**APPENDIX A**  
**INITIAL STUDY AND NOTICE OF PREPARATION**

# Notice of Preparation

SUBJECT: **Notice of Preparation for a Draft Environmental Impact Report**

**Project Title:** Morgan Industrial Park Specific Plan / EIR

PRELIMINARY ROAD IMPROVEMENT PLAN  
PRELIMINARY GRADING PLAN

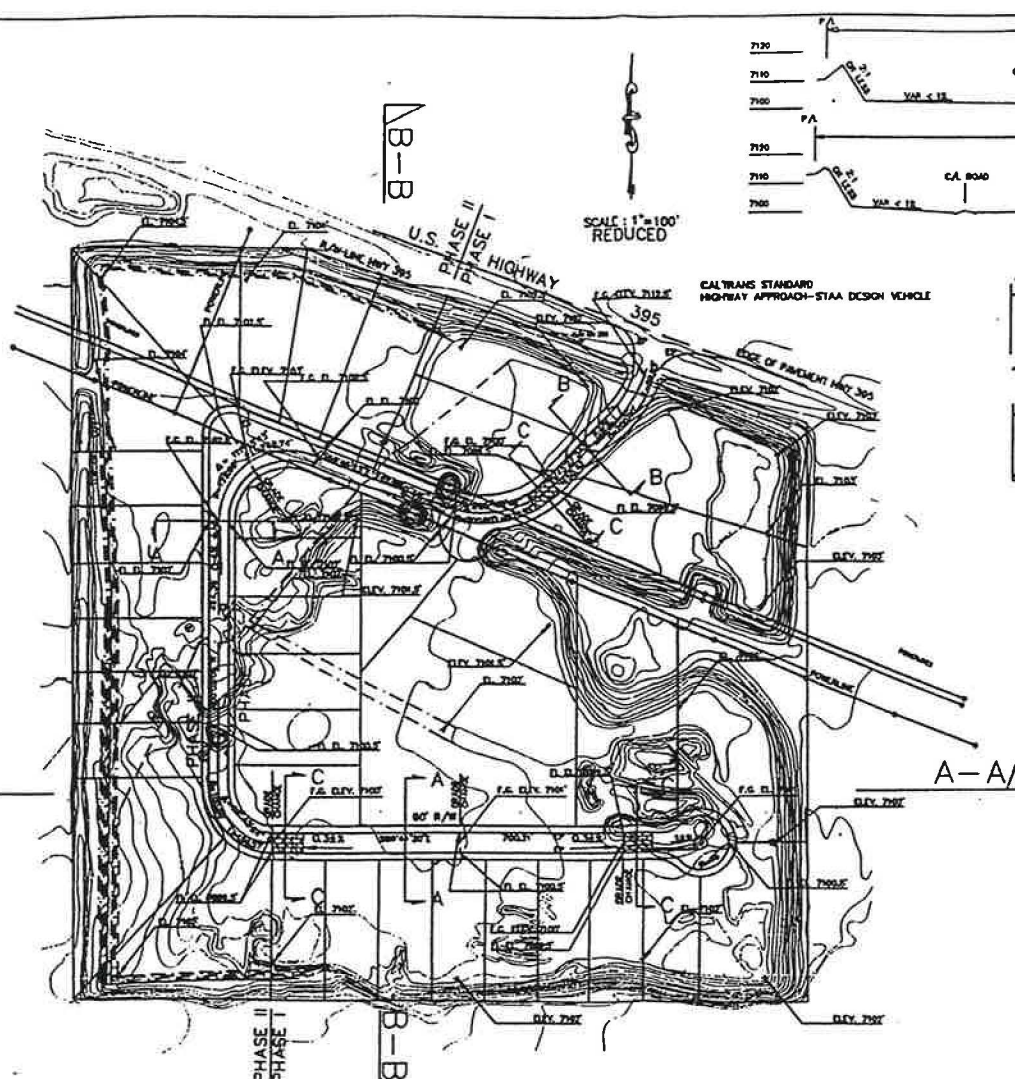
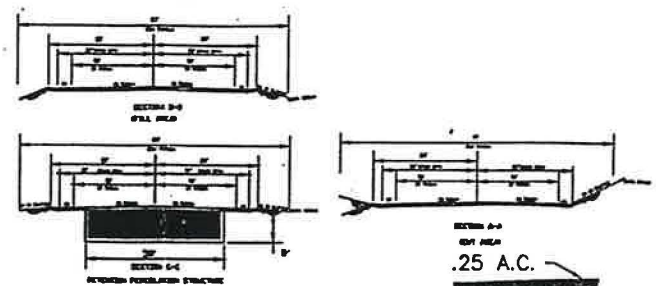
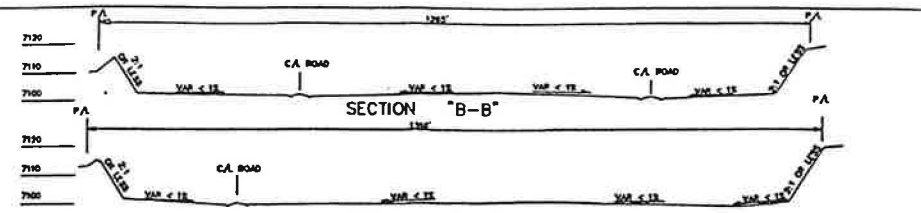
The Public Works Department has concerns about the location of storm water retention basins under the roadways. A drainage study and proposed drainage improvement plan is required. The drainage study and improvement plans are to be prepared and signed by a State of California, Registered Civil Engineer. The grades shown on the "Preliminary Road Improvement Plan" shall be a minimum of 1%.

The plan shows some intersection widening. A minimum design will be the standard public road intersection as shown in the Highway Design Manual.
